S-8000II S-3000III S-3000IV

SHERWOOD SERVICE DATA BULLETIN

All S-8000II, S-3000III with serial number 3223261 and up, S-3000IV with serial number 3224501 and up

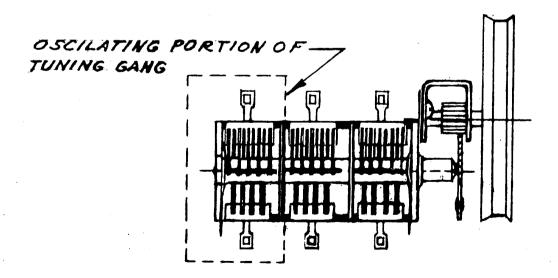
This can be detected by any one of three different methods. While looking at the I.F.'s on a scope, take a NON-METALLIC tool and applying pressure, slide the tool across the stator plates on the oscillator section of the tuning gang. If the I.F. pattern shifts and at the same time the oscillator grid voltage drops or rises along with the tuning eye opening. This indicates a defective tuning gang, Part number Bl25L4

- 1. heat and break solder connections on oscillator stator plates front and back.
- 2. remove oscillator stator plates completely.
- 3. place on bench, exposing bottom of stator plates. run solder over portion of plates where it is staked (NOTE:) stator plates are aluminum and will not take solder, but solder can be flowed around aluminum plate.

- 4. re-install stator plates and solder in place
- 5. re. log.
